# Work Order ID 94875

Item Name: Crosstube Assembly, Mid Aft

DRAWING NO. D206-667-247  
REV. A  
SHEET 1 OF 4

DRAWING NO. D206-667-247	TITLE CROSSTUBE ASS'Y (206L MID AFT)	REV. A	<b>DART AEROSPACE LTD ENGINEERING ORDER</b>		D.E.O. NO. D206-667-247-A-1	SHEET NO. SHEET 1 OF 1	SCALE NTS
DRAWN <i>q</i>	CHECKED <i>ASS</i>	MFG. APPR. <i>KB</i>	APPROVED <i>IMP</i>		DE APPR. <i>#</i>		
DATE 11.07.15	DATE 11.07.20	DATE 11.07.21	DATE 11/07/21		DATE 11.07.21

<b>DART AEROSPACE LTD</b>		<b>Work Order:</b> 94875
<b>Description:</b> Crosstube Assembly, Mid Aft		<b>Part Number:</b> D206-667-247TRN
<b>Inspection Dwg:</b> D206-667-247 <b>Rev:</b> A		<b>Page 1 of 2</b>

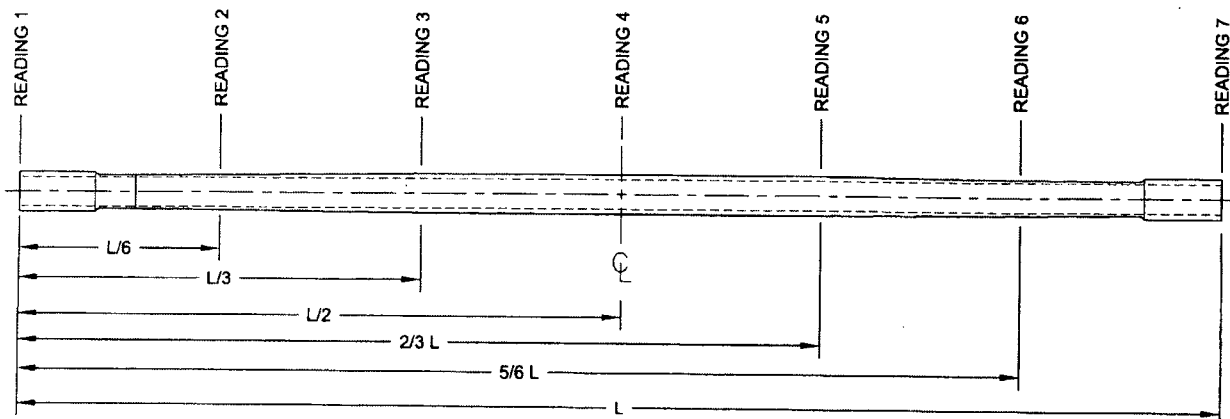
Root Cause	Date	Step	Qty	Description of work order update or Non-conformance	Initial Chief Eng	Action Description	Sign & Date	Verification	QC Inspector
Doc/Data <input type="checkbox"/>	13/1/8	110	1	tube has Measurements over tolerance throughout.  Dim 2.025 is 2.035. Max of 0.001 elsewhere	DAS 12 13/1/8	Acceptable	DAS 12 13/1/8	TW 13-01-09	13/1/10
Equip/Tooling <input type="checkbox"/>									
Operator <input type="checkbox"/>									
Material <input checked="" type="checkbox"/>									
Setup <input type="checkbox"/>									
Other <input type="checkbox"/>									
Process <input type="checkbox"/>									
Supplier <input type="checkbox"/>									
Training <input type="checkbox"/>									
Unapproved <input type="checkbox"/>

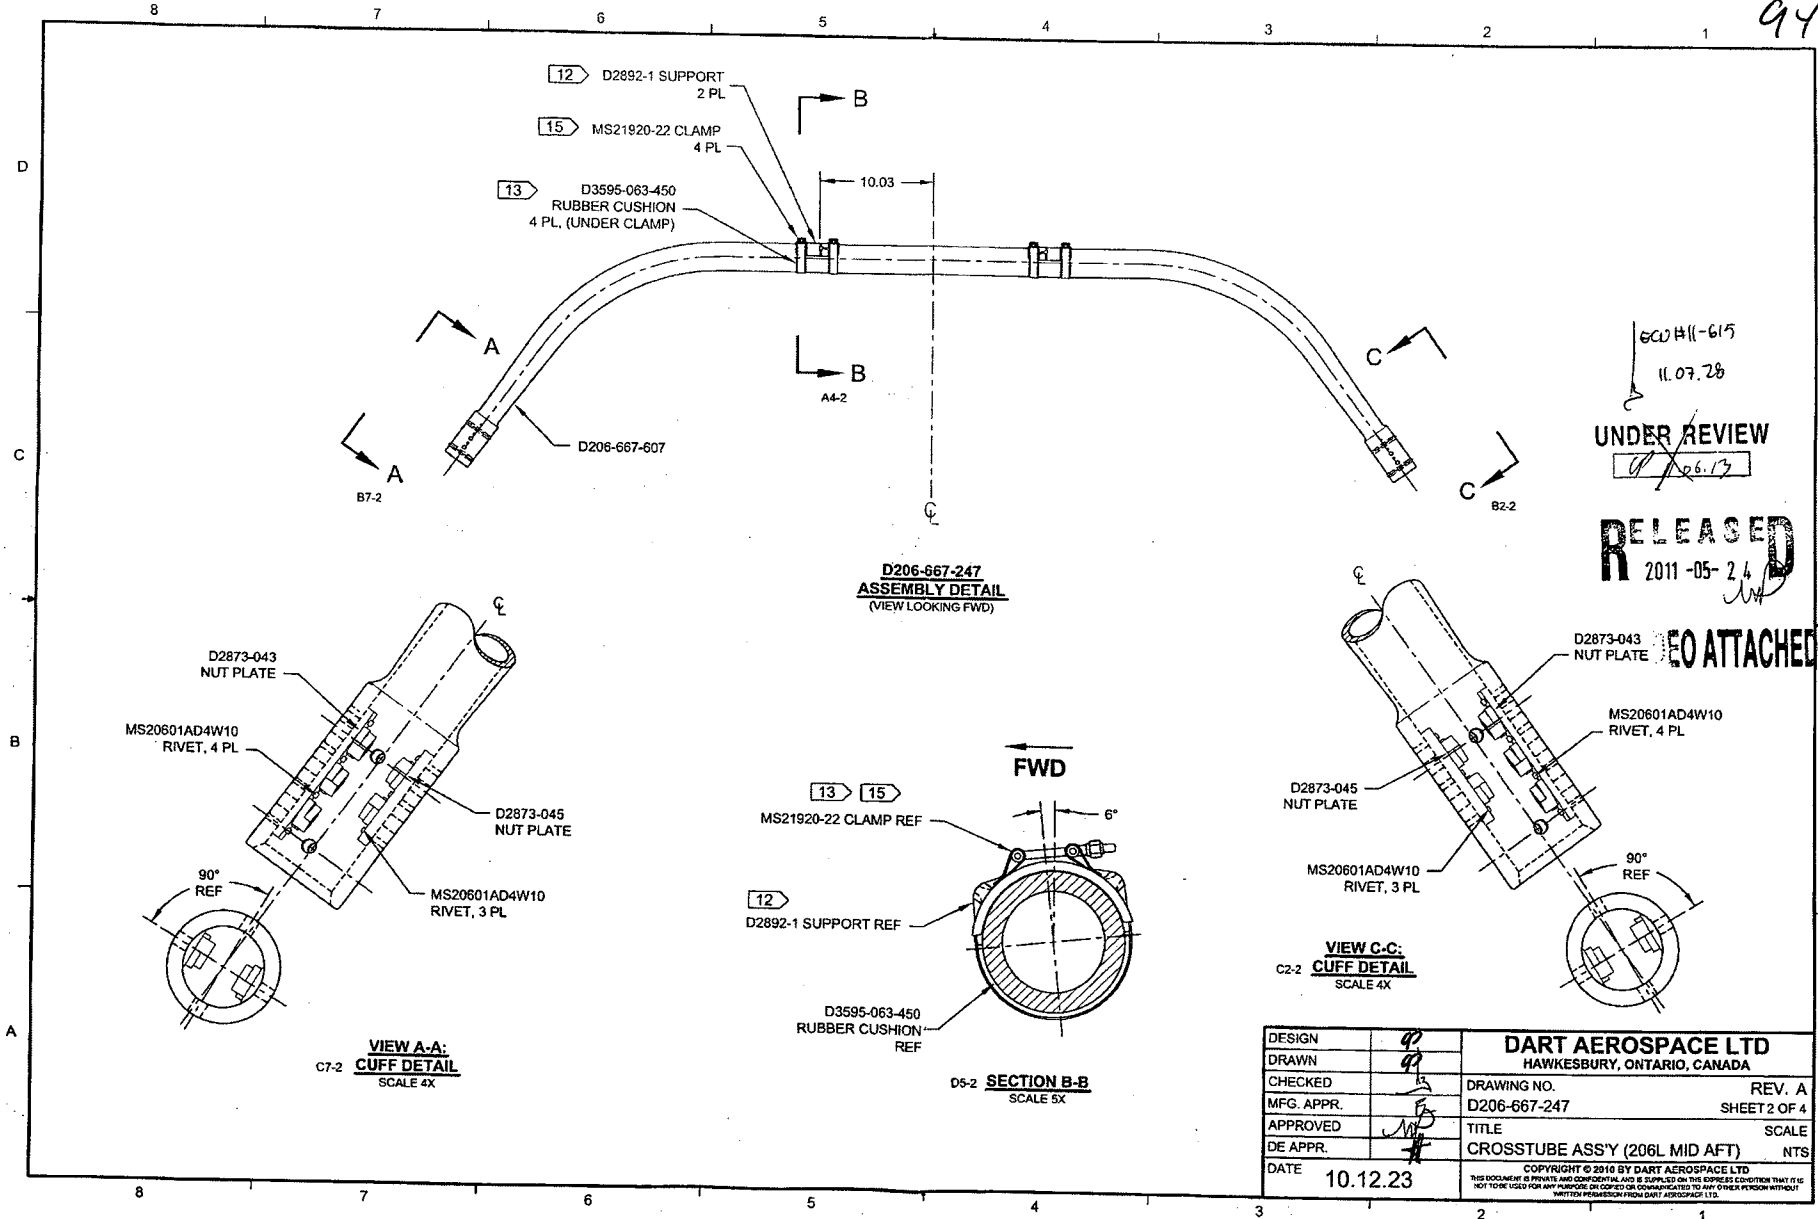
**PURPOSE:**

REPLACE MAGNOBOND WITH PROSEAL.

NOTE 12 & 15, SHEET 1 IS AMENDED AS FOLLOWS:

IS:

Item	Qty -247	Part Number	Description
9	A/R	PROSEAL 890 B-2	SEALANT, AMS-S-8802 CLASS B-2

IS:

- 12) TO INSTALL D2892-1 SUPPORT: ABRASE MATING SURFACE OF SUPPORT AND CROSSTUBE WITH 180-GRIT SANDPAPER AND REMOVE RESIDUE WITH MEK (OR EQUIVALENT). APPLY A 0.04" TO 0.07" THICK LAYER OF PROSEAL 890 CLASS B-2 (OR AMS-S-8802 CLASS B-2) SEALANT TO MATING SURFACE OF SUPPORT.
- 15) TORQUE CLAMPS 80 TO 100 IN.-LB. ENSURE AT LEAST 1.5 THREADS SHOWING IN SAFETY AND THAT NUT HAS NOT BOTTOMED-OUT AFTER TORQUING. **PRIOR TO PACKAGING, RE-CHECK TORQUE ON CLAMPS AFTER PROSEAL 890 SEALANT HAS CURED FOR 72 HOURS.**
